Notice of Allowability

10/648,397

Annotated Marked-up drawings

FIG.1

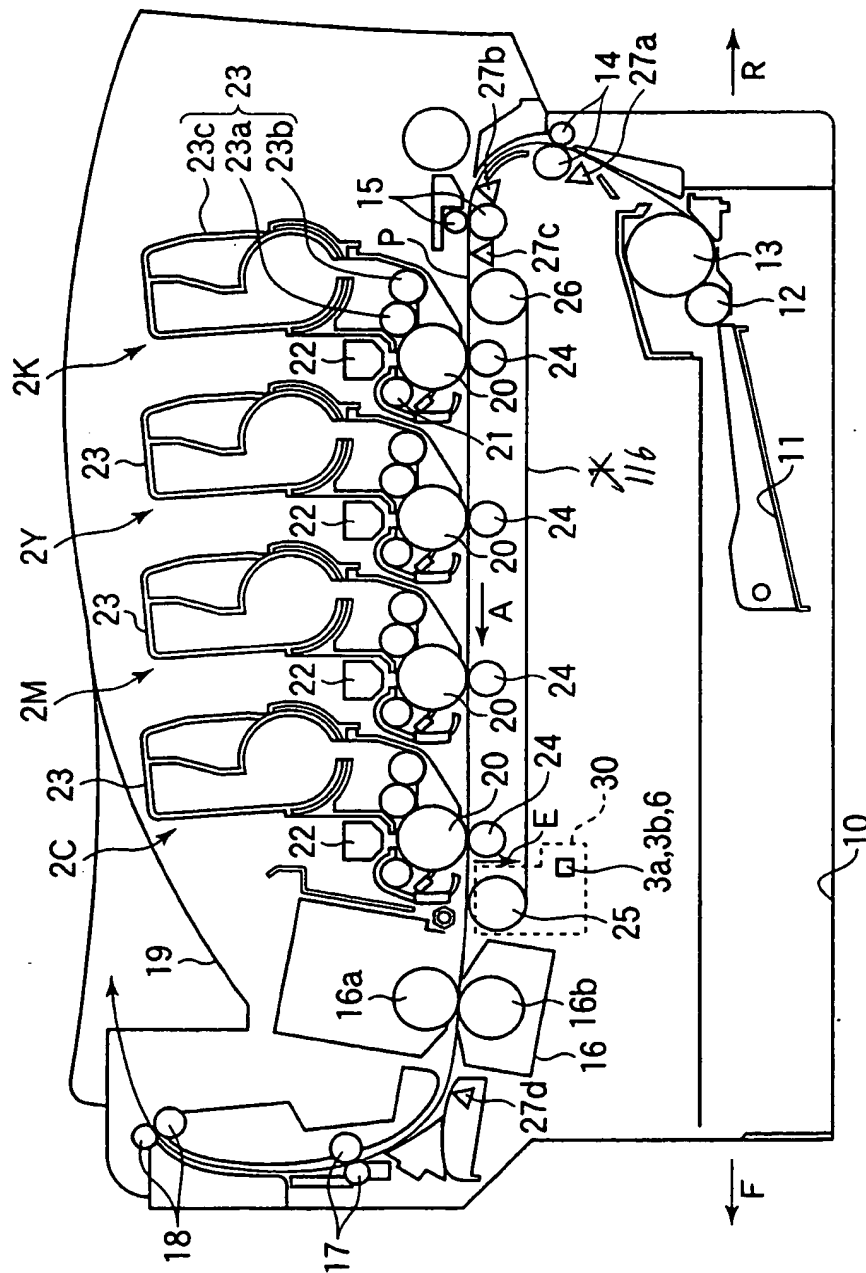
Corrections
Approved
MMH
7/22/05

FIG.2

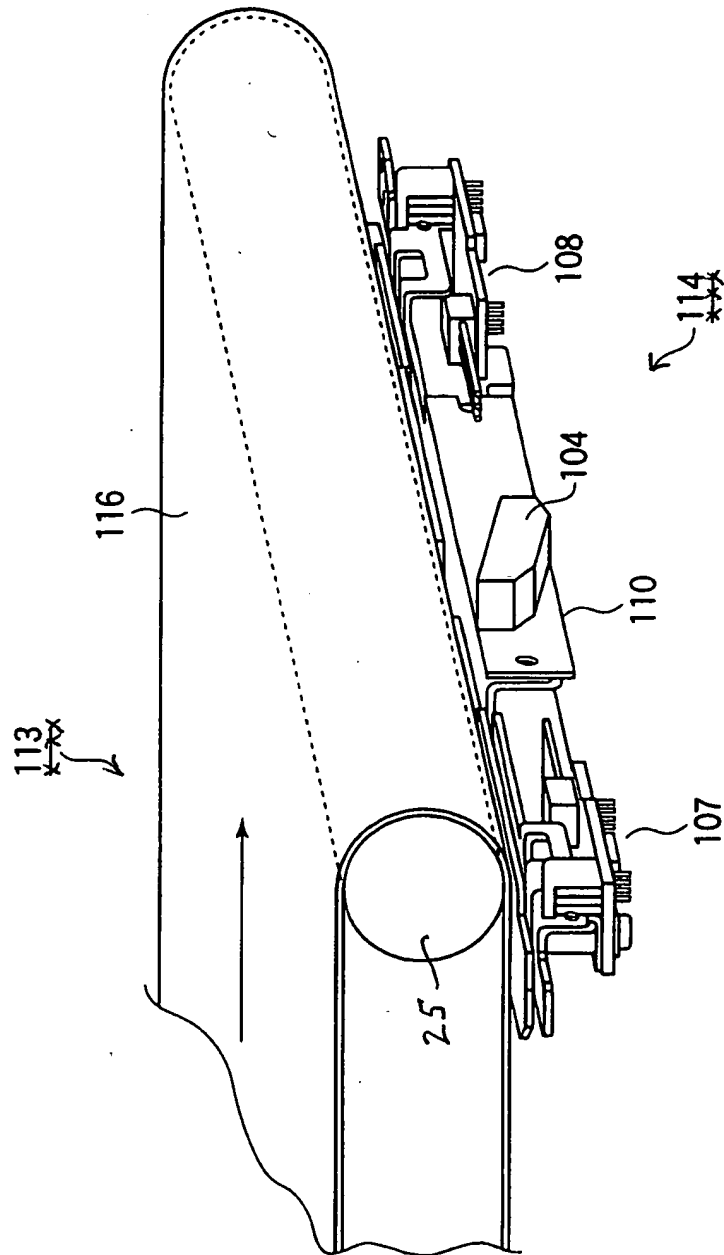
Correction
approved
7/22/05
MOR

FIG.4

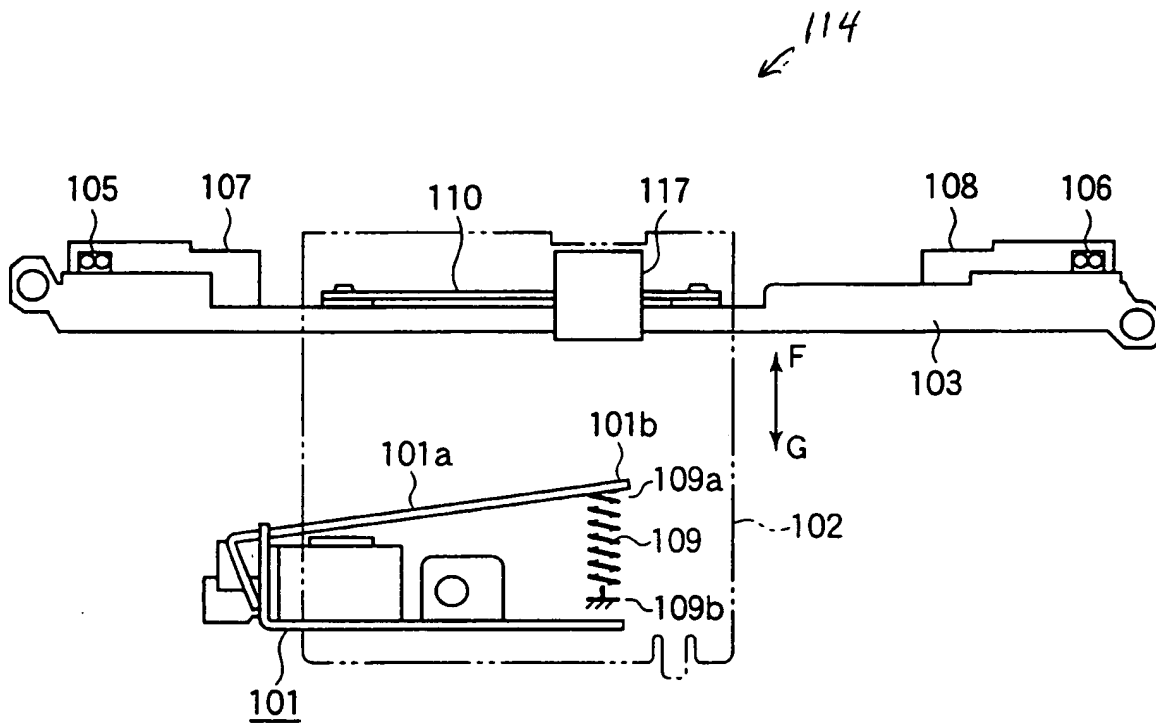
Corrections
around
MPL
7/22/05

FIG.5

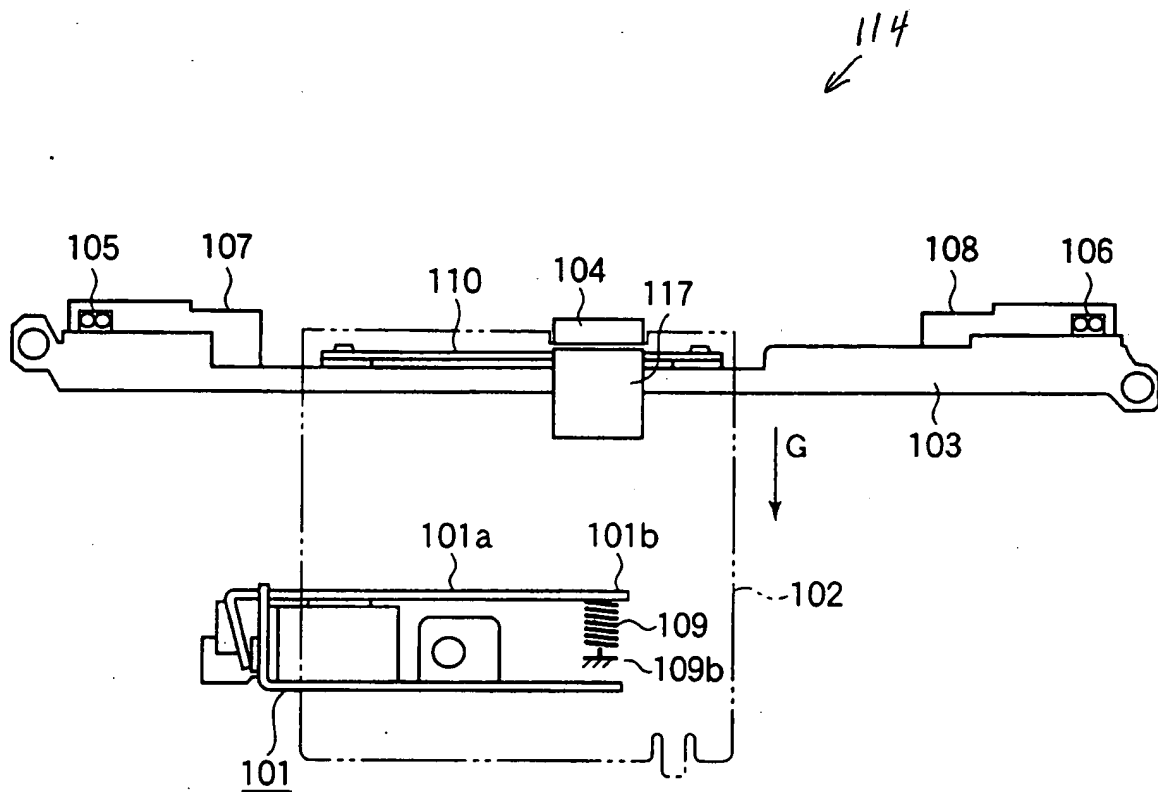
Corrected
around
M/A
2/22/65

FIG.6A

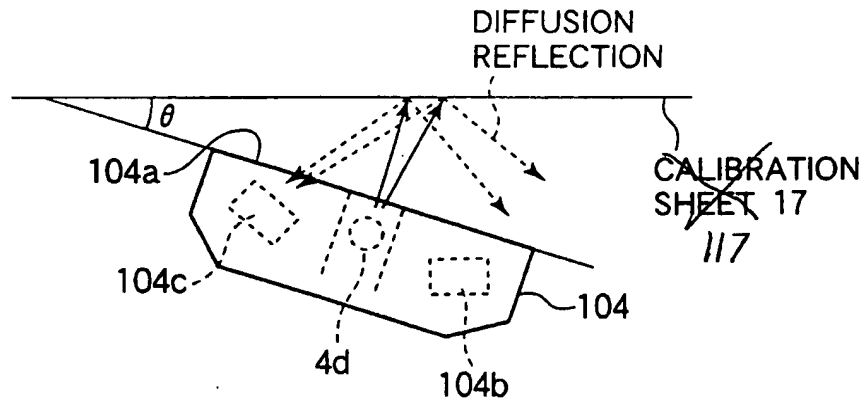
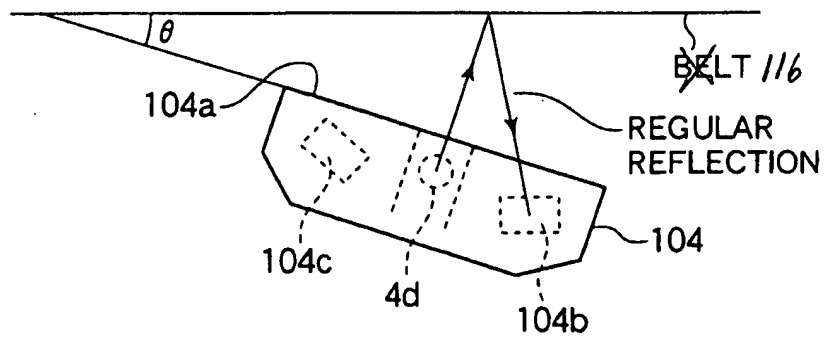
connections
approved
MHN
7/22/05

FIG.16

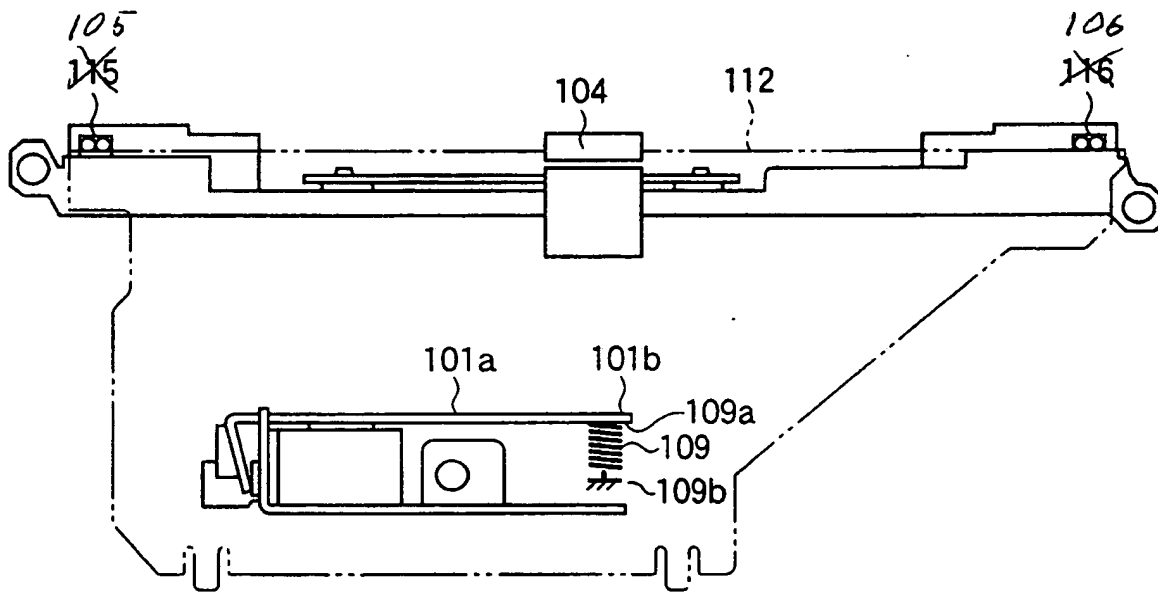
connection
around
mm
7/22/05

FIG.19

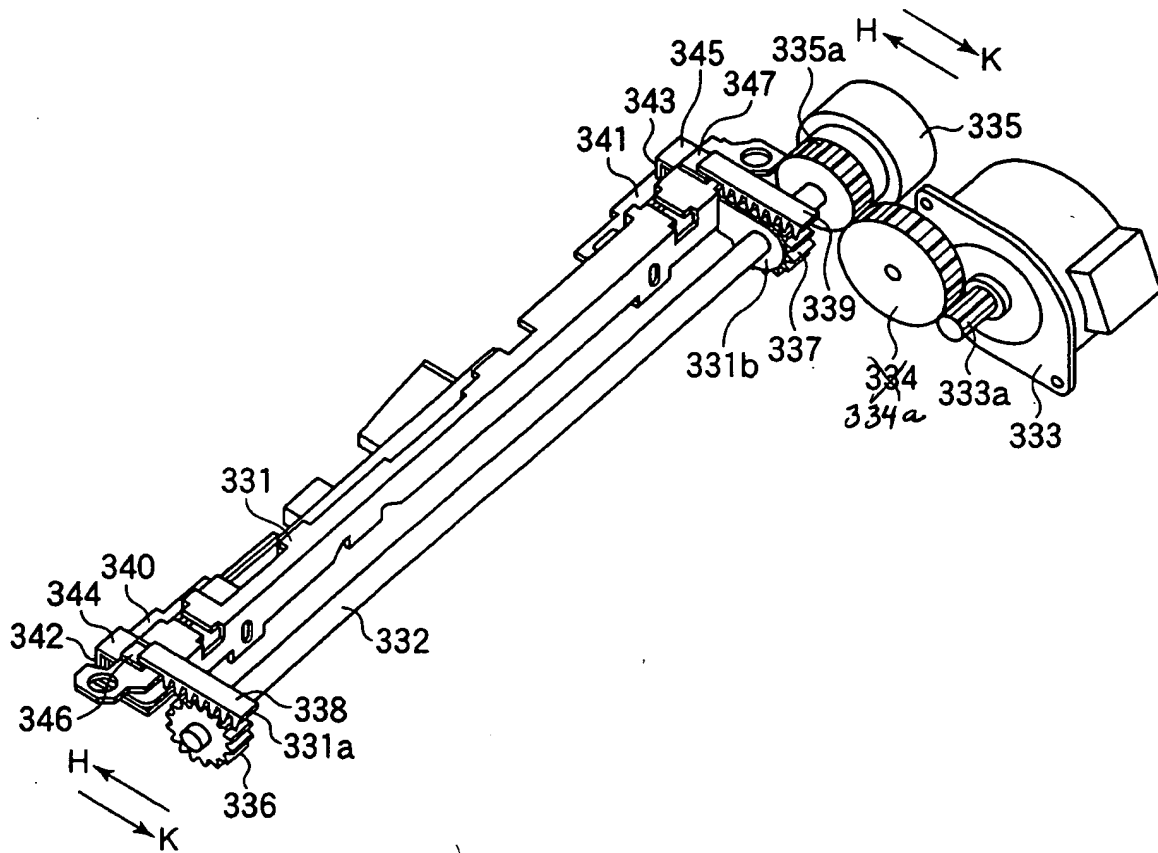
Correction
as above
MGN
7/22/05

FIG.20

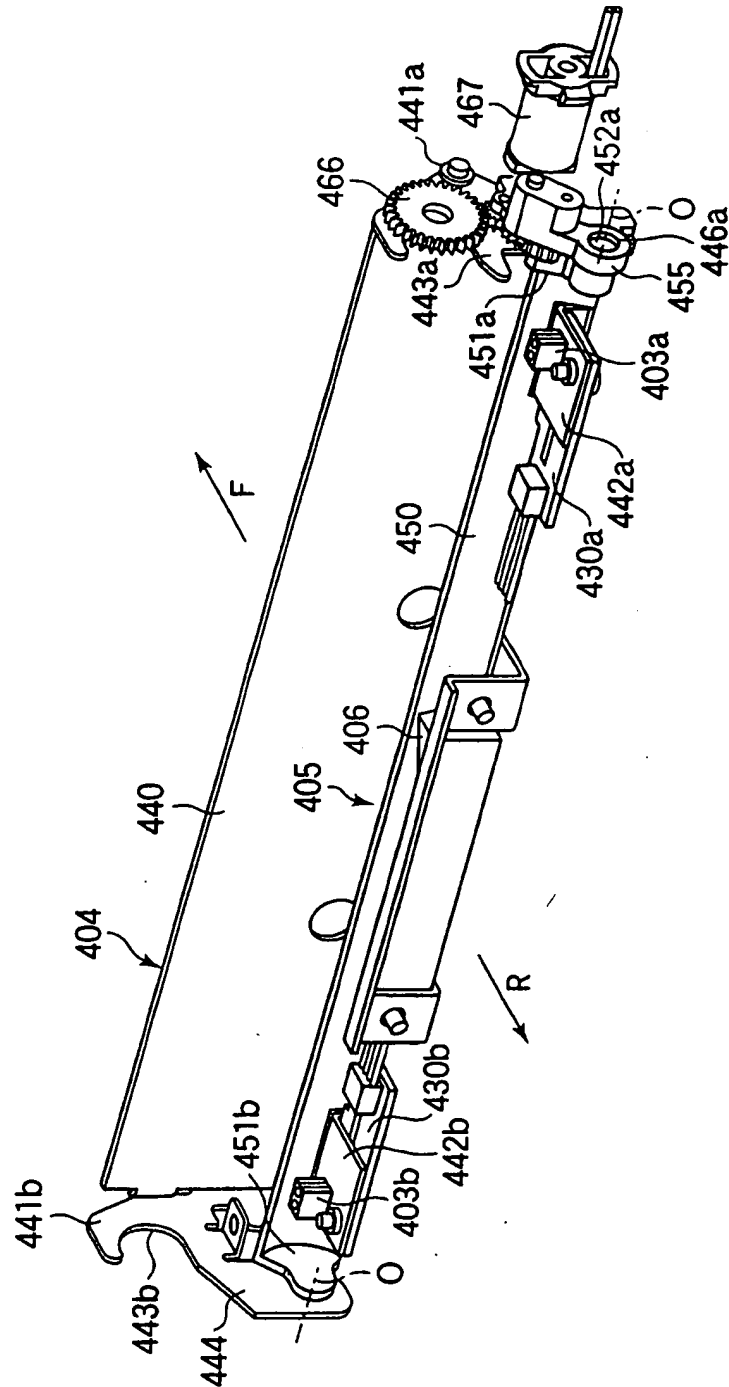
Correction
closed
mgn
7/22/05

FIG.21

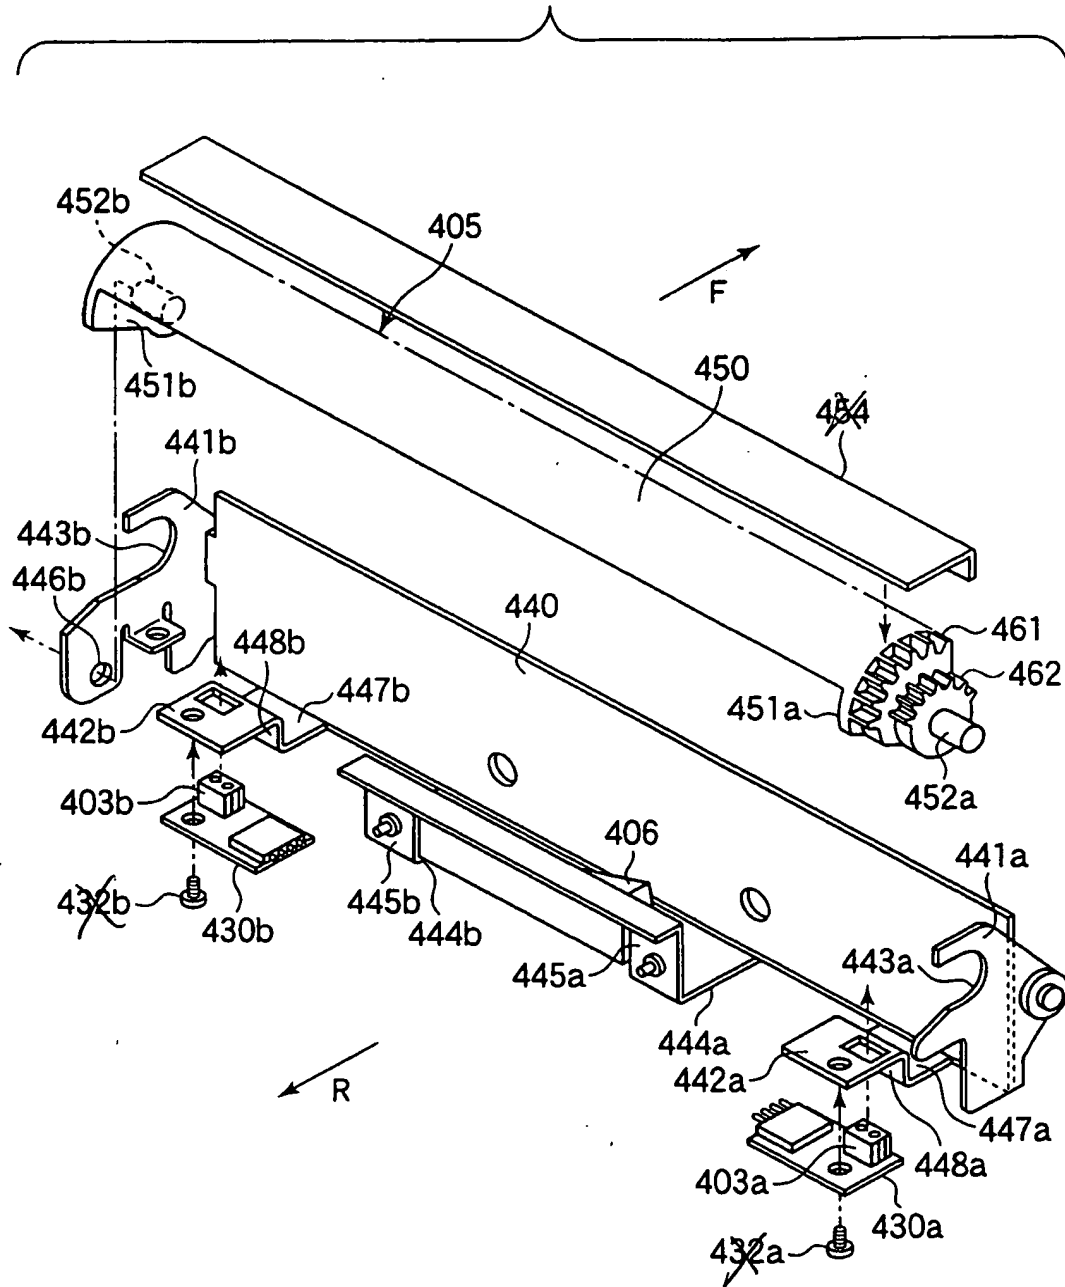
Connections
around
NVH
7/22/05

FIG.22A

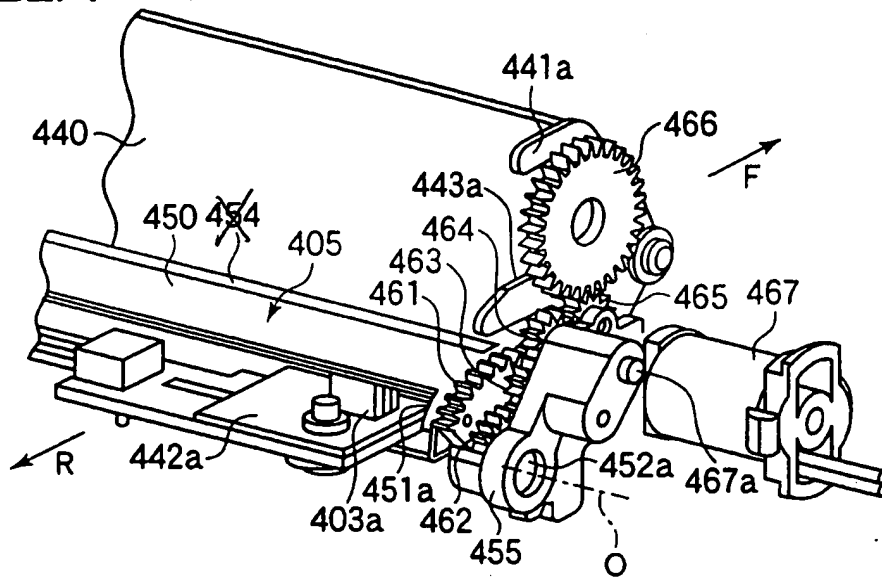
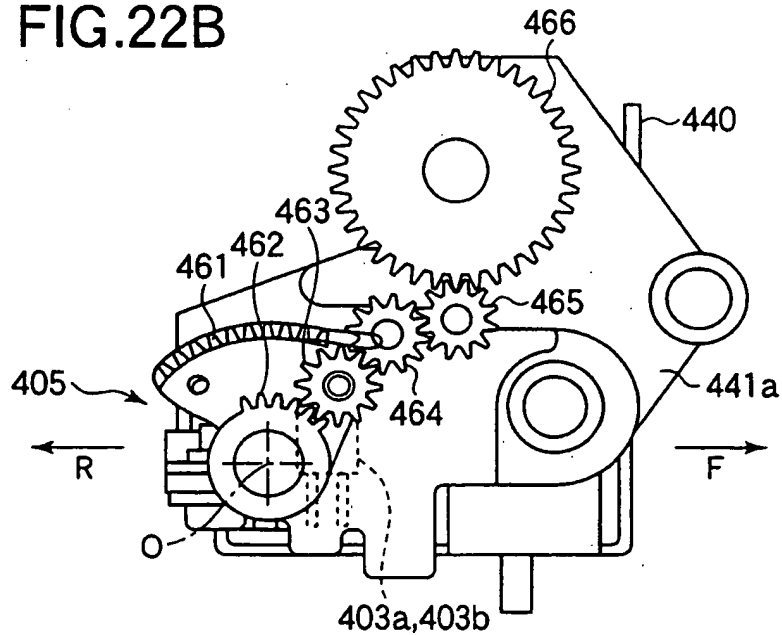
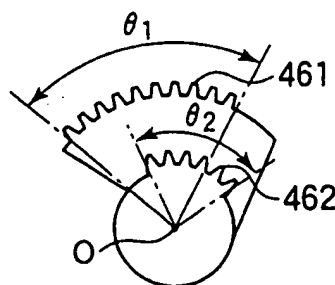
Correction
approved
7/22/85
MOR

FIG.23A

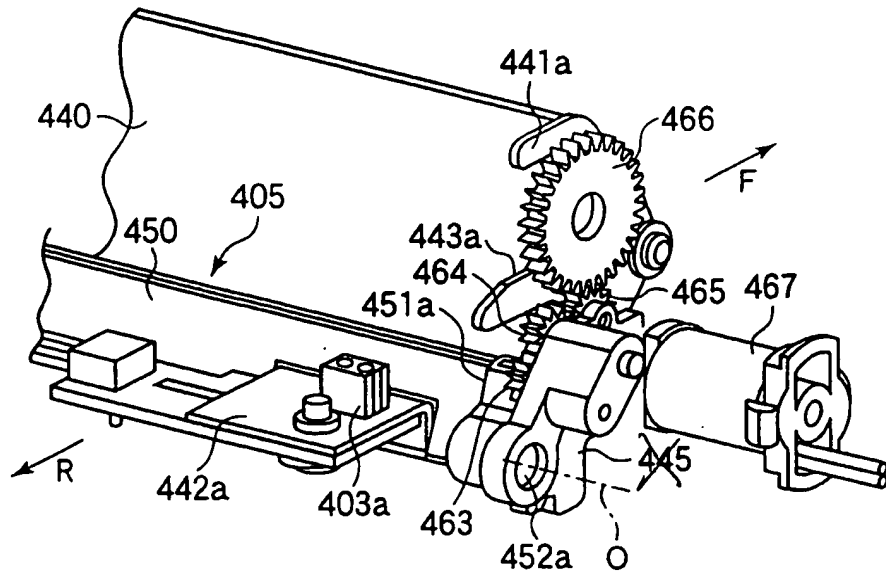
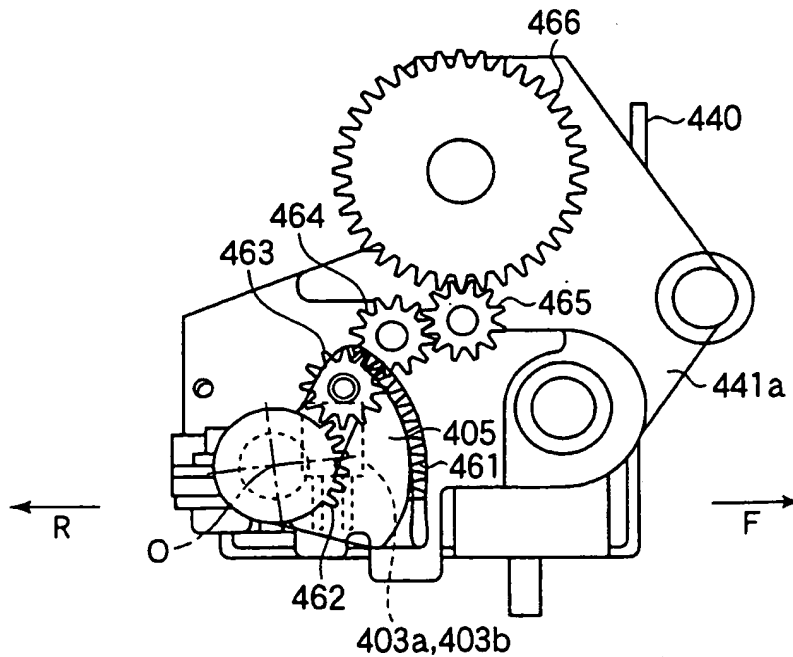
Connectors
applied
MBA
7/22/05

FIG.24A

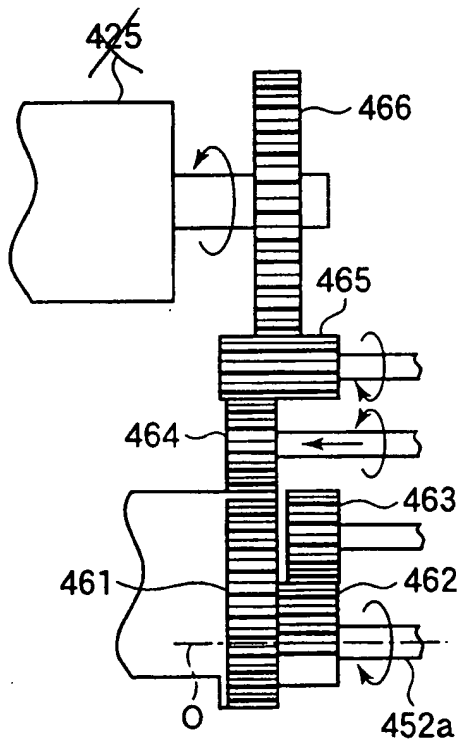
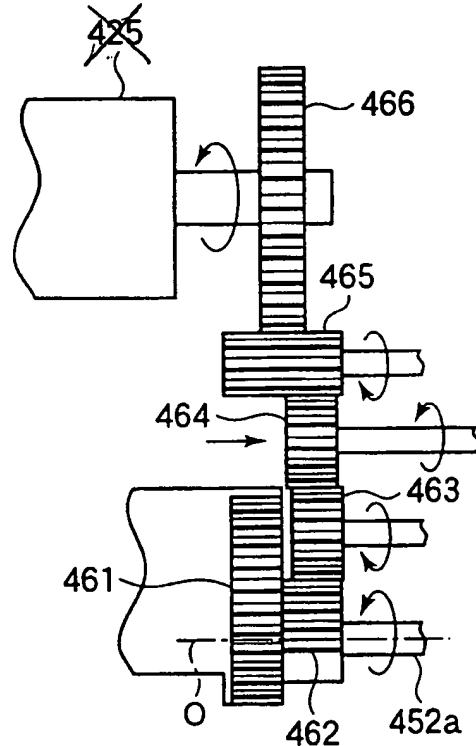
Correction
optional
MRR
7/22/05
